HORNSBY AQUATIC CENTRE

POTENTIAL ACCESS ARRANGEMENT INDEPENDENT REVIEW

Project No. X12109

Prepared for Hornsby Shire Council

Figure 4- Option 1 Modified to RMS requirements

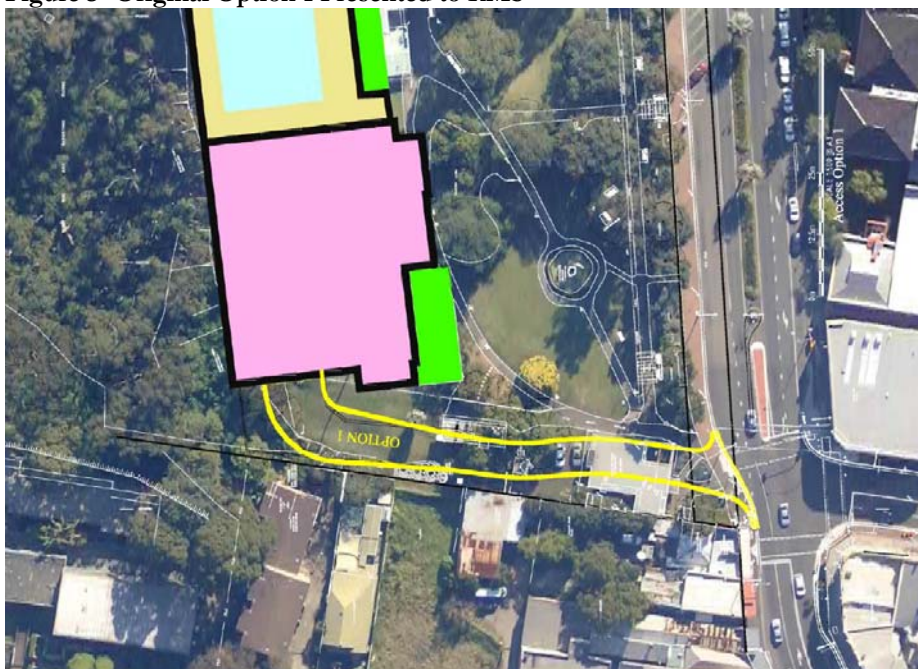
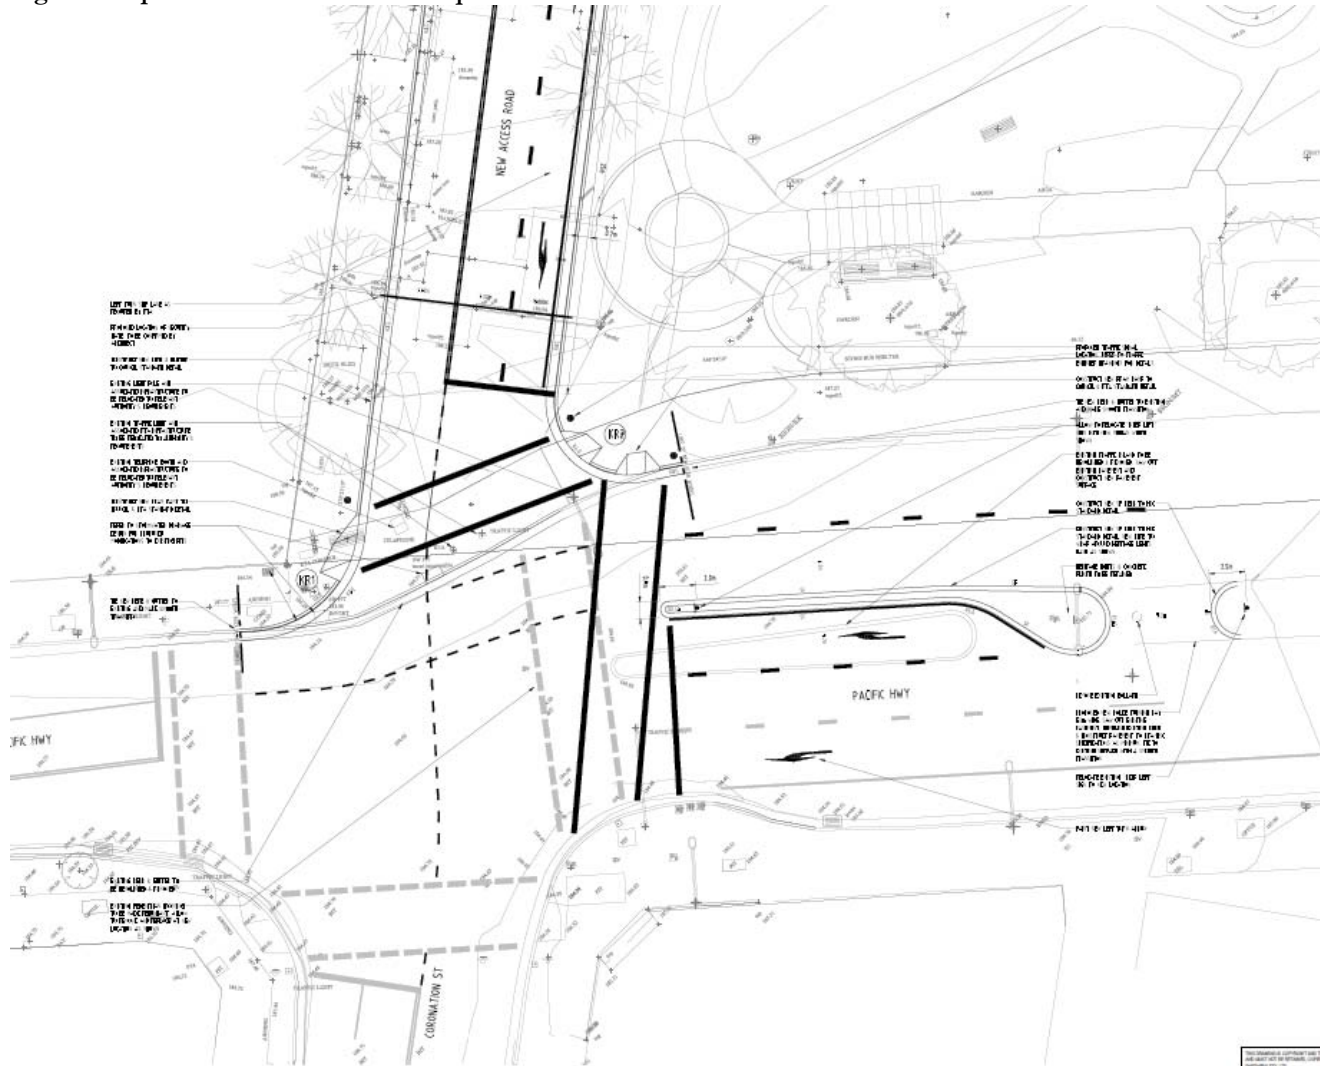
It is understood that the advice from RMS was the HAC could be serviced from the traffic signals at the intersection of Pacific Highway / Coronation Street, however, the access road must be widened to provide two exit lanes for a distance of some 25m into the site. This would allow the creation of a left turn lane and through / right turn lane. The configuration instructed by RMS is provided below.

Figure 8 - Option 2 Access north of Women’s Rest Centre building

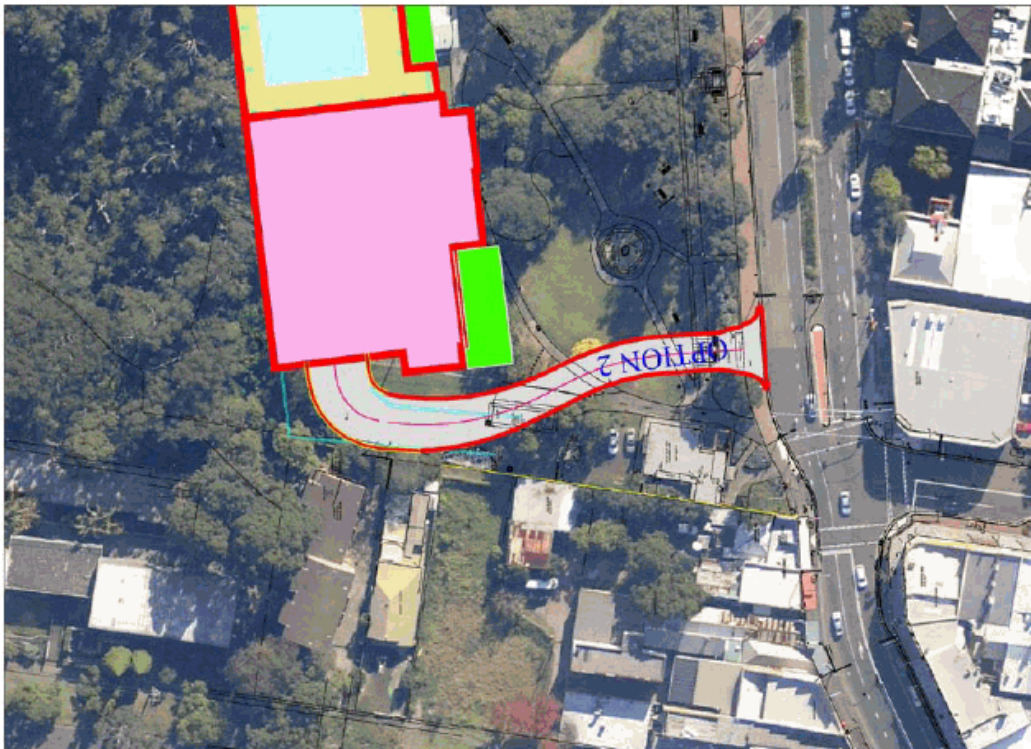
Option 2 is limited to left in left out only and will reach capacity in 2021. Whilst Option 2 is not desirable because of poor access from the north, it does address a number of issues raised by the JRPP including the retention of the Women's Rest Centre, is a less engineered solution (driveway not a road and narrower) and does not require major works on the Pacific Highway. It is also respectful of existing plantings in that no heritage listed turpentine trees will be disturbed by this option. However, it should also be noted that approximately eight (8) of parking spaces on Pacific Highway will be lost and has other heritage impacts on the park.

Figure 9 - Option 3 - Access northern end of Hornsby Park – widen existing access

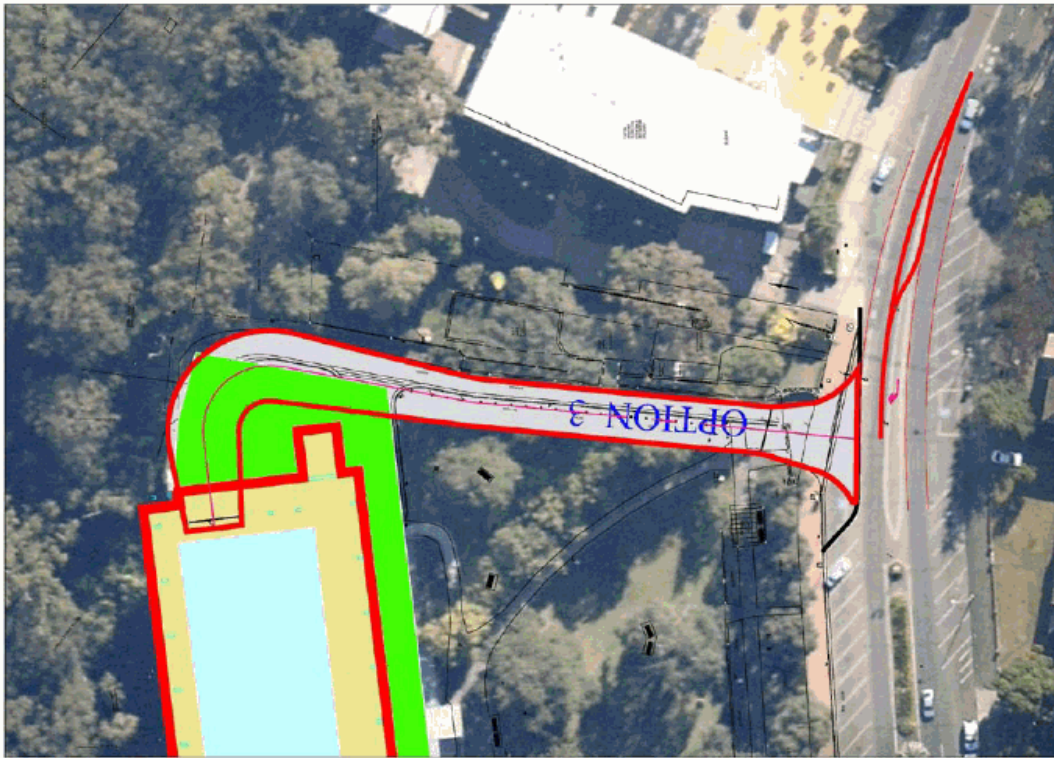
Site distance for exiting traffic was noted to be poor. For the exit onto the Pacific Highway, extending the footway area to the edge of the through traffic lane, as proposed in the Westside Masterplan, is required. Further, there is inadequate space between the boundary and the centre to accommodate an exit ramp, including queuing which complies with AS2890.2 and provides a section of relatively flat grade to accommodate queuing in accordance with AS2890.1.

Figure 13 - Option 7 - Access via Old Man's Valley fire trail

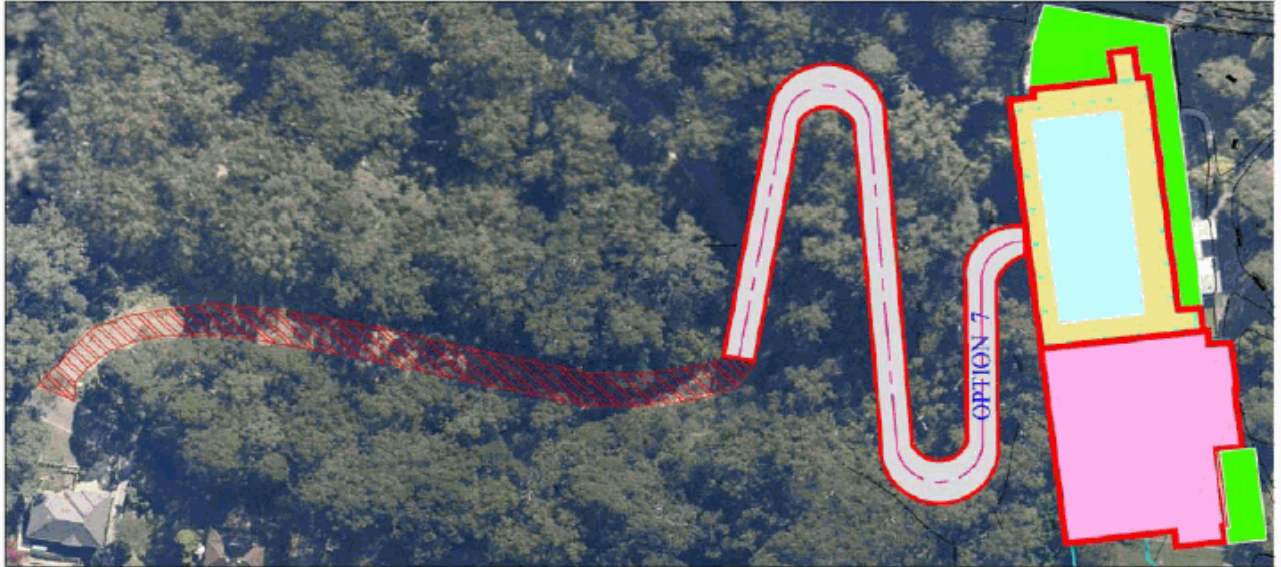
All other options include elements which would not be compliant with relevant standards or would require diminished traffic arrangements with adjoining developments. Option 7 provides the poorest access arrangements of any option with access being via a convoluted route.

Option 7 is seen as visually intrusive and its hairpin bends somewhat hazardous.

Figure 16 - Option 10 - Access through playground northern side of Hornsby Park

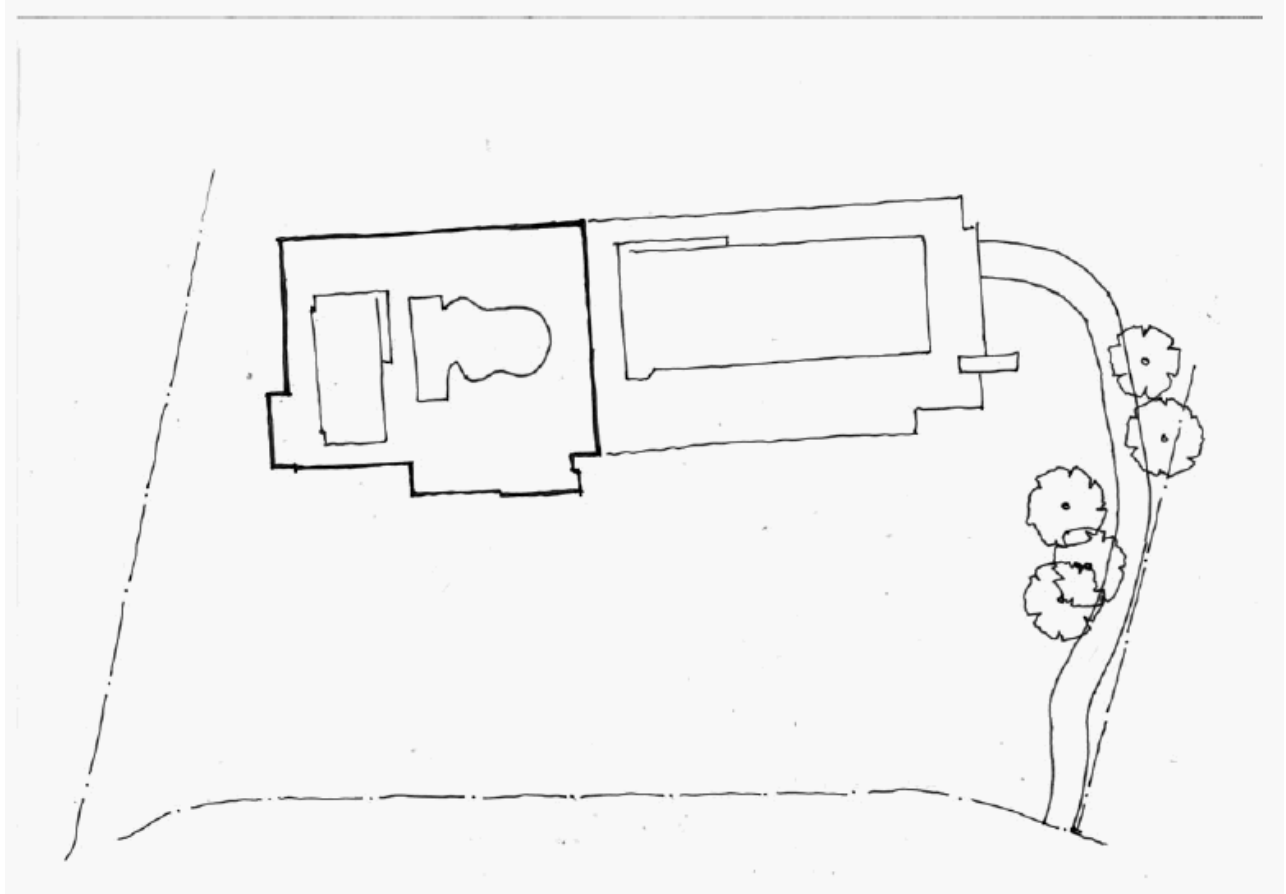
Options 10 and 11 are unsatisfactory because too many heritage-listed turpentine trees and a dry stone wall would need to be removed, and both the children's playground and BBQ table and shelter would have to be removed or relocated elsewhere in the park. Moreover, as the land level is higher along the northern boundary, it would be more difficult to get down to the desired level of the base of the car park. **Option 4** – on land owned by TAFE, not Council - would suffer from similar problems.

Figure 18 - Option 12 – Left turn slip lane as modified Option 1

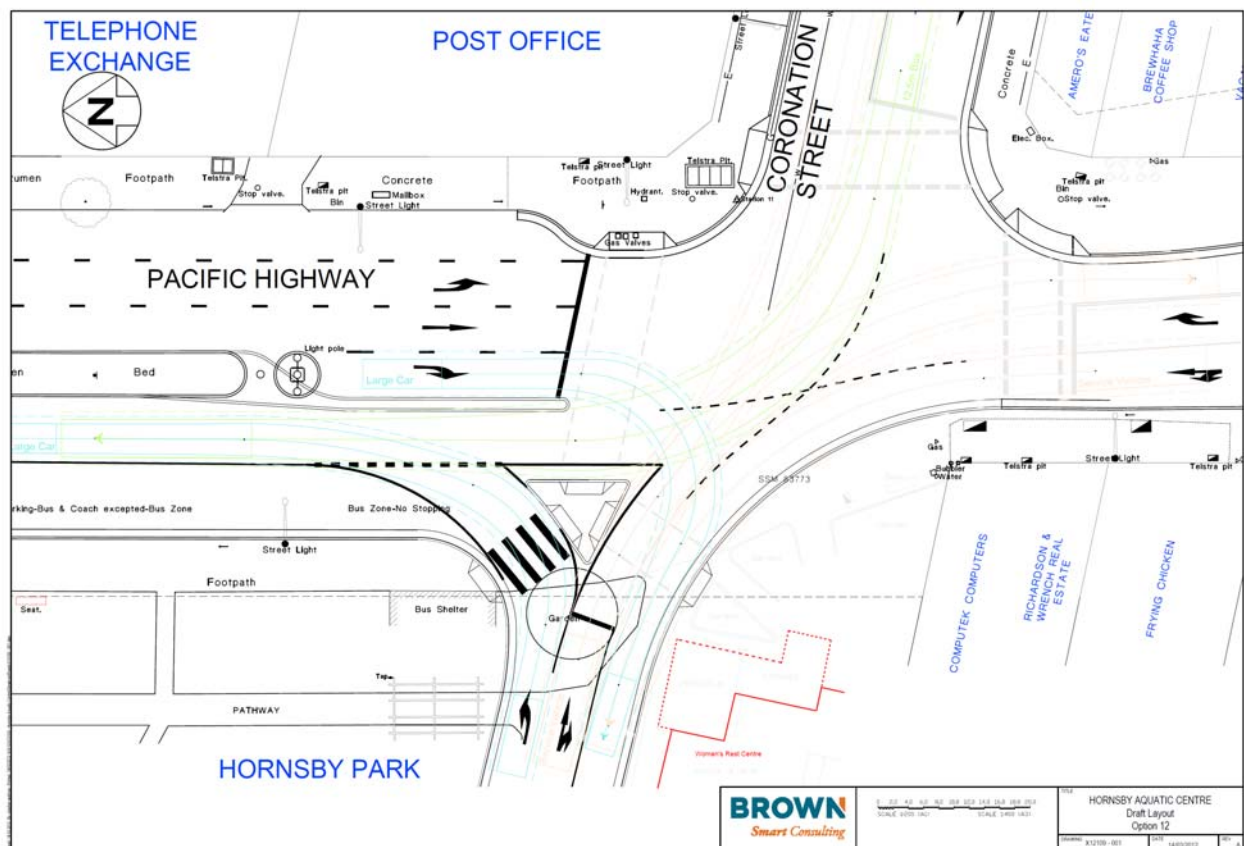
This option would provide all the benefits that Option 1 provides and maintain the Women's Rest Centre building. A deficiency of the Option 12 arrangement compared with Option 1 is that pedestrians walking on the western side of the street would be required to cross two roadways instead of one. Further, the greater than 90 degree right turn from Pacific Highway would not be supported by RMS.

Option 12 would require the relocation of the existing bus zone on the western side of the Pacific Highway and would require demolition of the existing bus shelter to provide safe pedestrian sight distance. Approximately three (3) parking spaces will be lost on the Pacific Highway with this option.

Fig. 8 Option 8, elaborated by Council

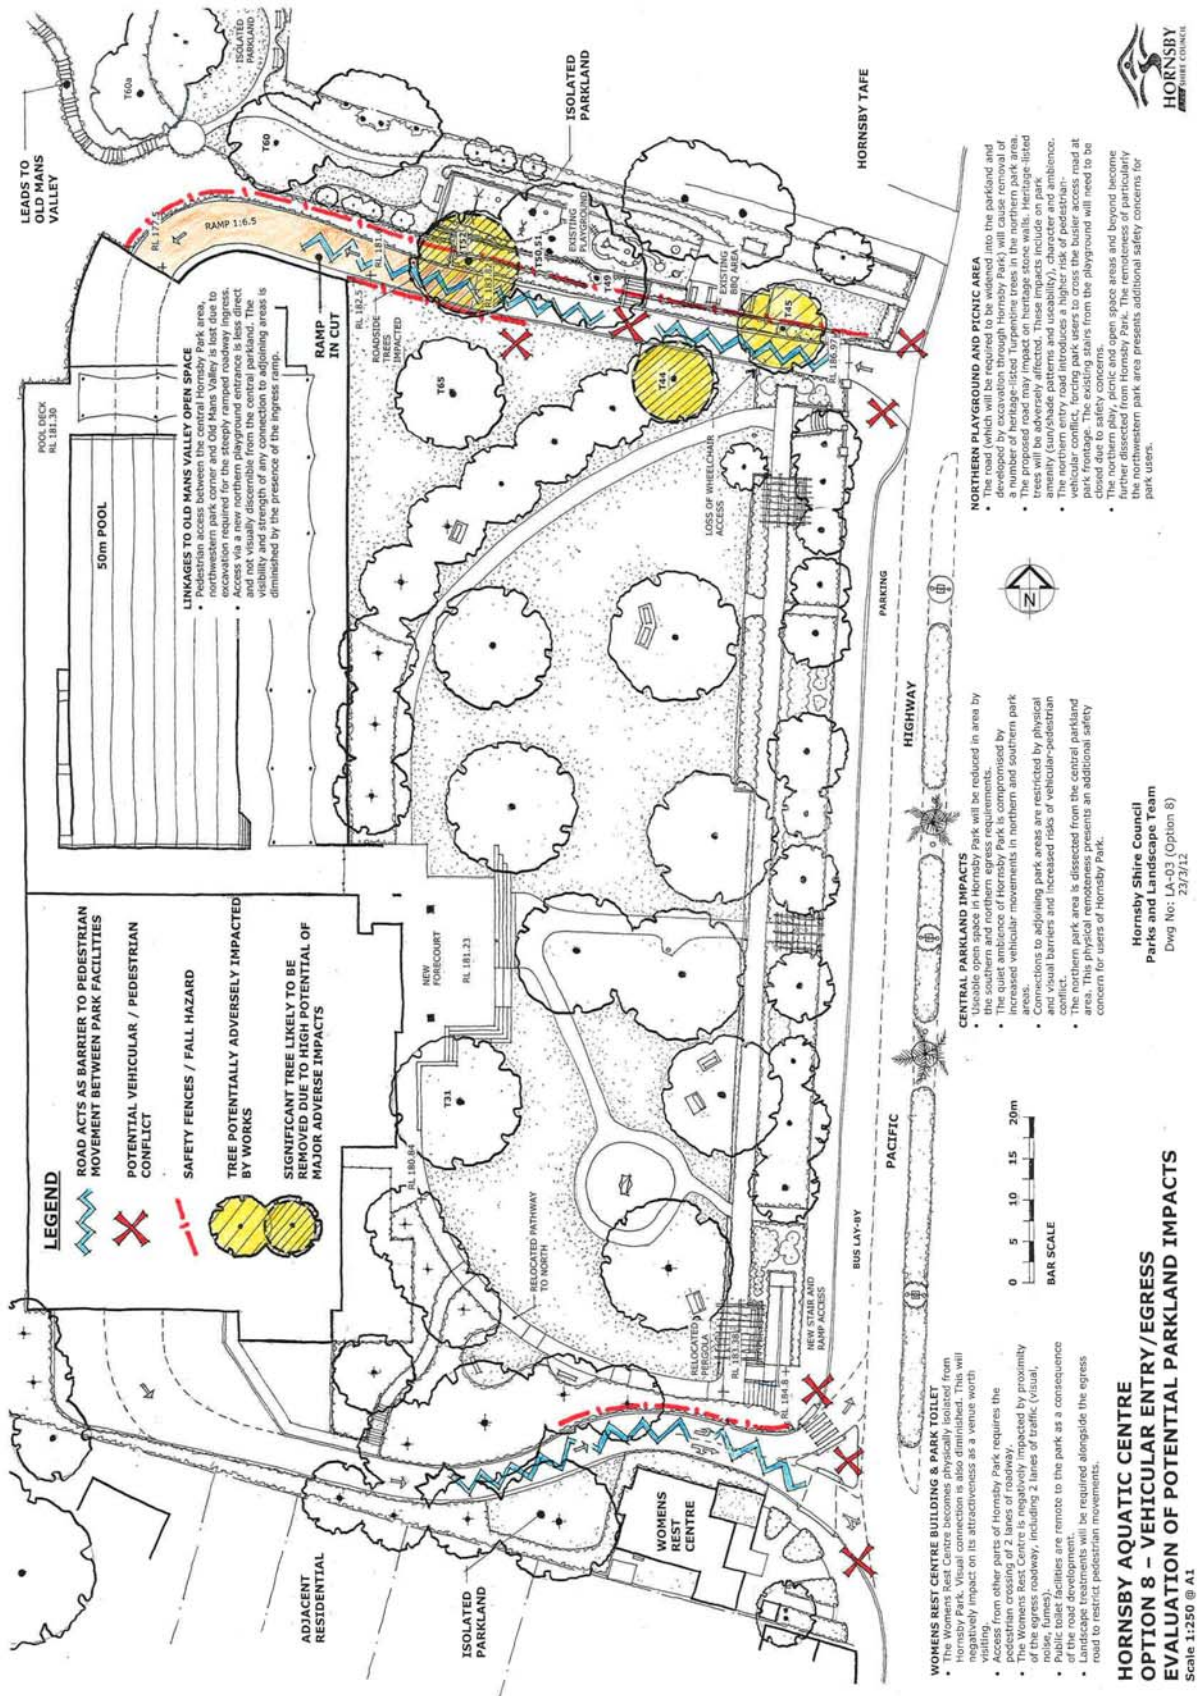
There is a rough verisimilitude between Options 8 and 9 to the original concept of the access driveway to the edge of the escarpment to enjoy the view down to Old Man's Valley, which gives it some attraction. However, the existing driveway pavements would have to be widened and level changes made, and there would be traffic entry and exit complications at both points where they join the Pacific Highway. As demonstrated in Option 8, investigations undertaken by Hornsby Council, indicate there would need to be changes to the alignment of the southern D-shaped pathway. More significant however are the impacts of vehicles utilising the northern entry road (Option 8). Vehicles will commence ramping down steeply well before reaching the aquatic centre and this would have a significant adverse impact on the park by permanently isolating and separating the central park areas from the northern playground and restricting linkages to Old Mans Valley.

Council has investigated alternative arrangements for this accessway (Option 8b) and found that by altering the alignment of this road into a curved form in the aquatic centre area, that the steeply ramped cutting can be confined to the aquatic centre building zone. This approach is superior to Option 8 as it enables a pedestrian crossing from the central parkland linking it to Old Mans Valley and facilitates the development of parkland to replace the existing informal gravel carpark. However Option 8b still has negative impacts on the playground area associated with the imposition of a relatively busy road through this portion of the park and the need to close off the existing stair connection to the children's playground. As noted by the arborist, both Options 8 and 8b have a high potential for major adverse impacts on the heritage Turpentine trees (Option 8 tree numbers 44 and 52; Option 8b tree numbers 44, 52 and 60). Other trees are expected to be adversely impacted however these are not likely to be major, if Council proceeds to construct a relatively expensive Bailey's Bridge solution as recommended.

Fig. 10 Option 12, as prepared by Hornsby Council. Some refinement of this design is intended.

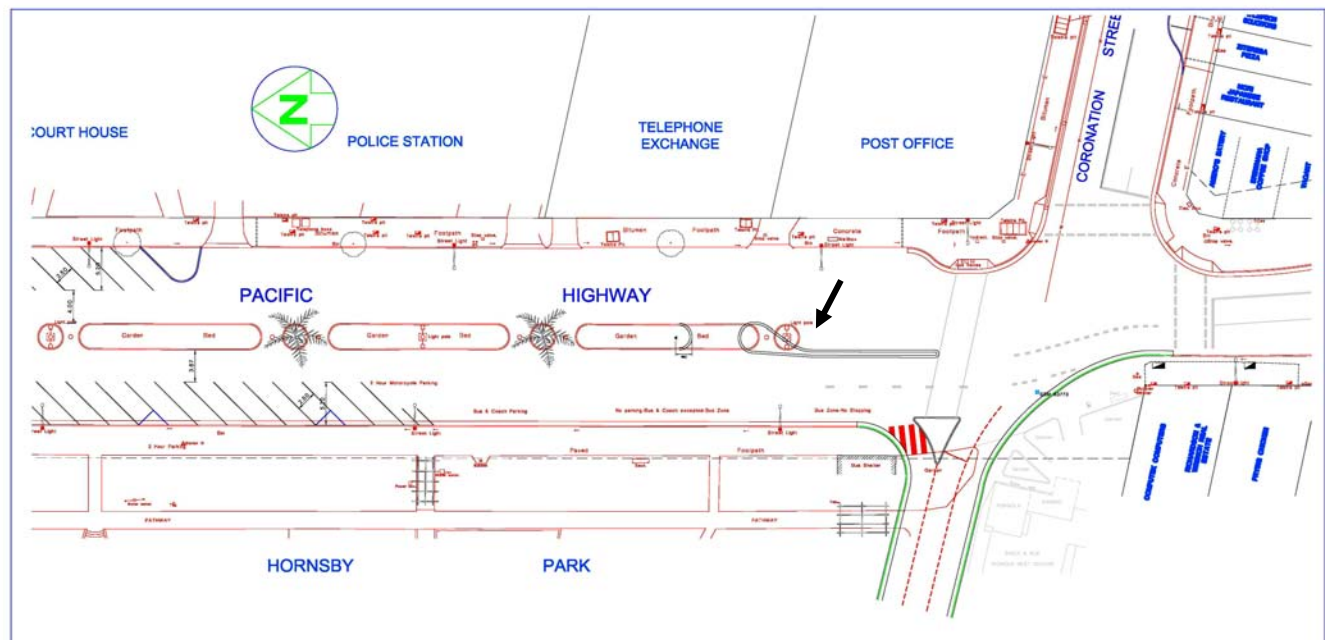
Option 12 is a compromise between options 2, 8 and 9.

We note that the landscape architect, Scrivener, considers this option “would require the compacting of competing pedestrian access, vehicular access, disabled path access and retention of important heritage items into too small an area to make it a viable alternative. The likely result is the demolition of the above mentioned items of significance to the fabric of the park, including the path alignments, the bus shelter, and the linear garden alignment along the S-E street frontage.” An attempt to provide a right hand turn into the park from just north of the Coronation Street junction (arrowed on Fig.10 above) could also necessitate the truncation of the central traffic island, and removal or relocation of its heritage street lamp. As both of these are regarded as important heritage elements of the composition of civic complex and park, such an action is considered most undesirable. An alternative intersection design involving the removal of the traffic island ‘blister’ on the eastern side of the highway, adjacent to the Post Office would appear to enable the central traffic island to be extended and the achievement of a more attractive outcome.
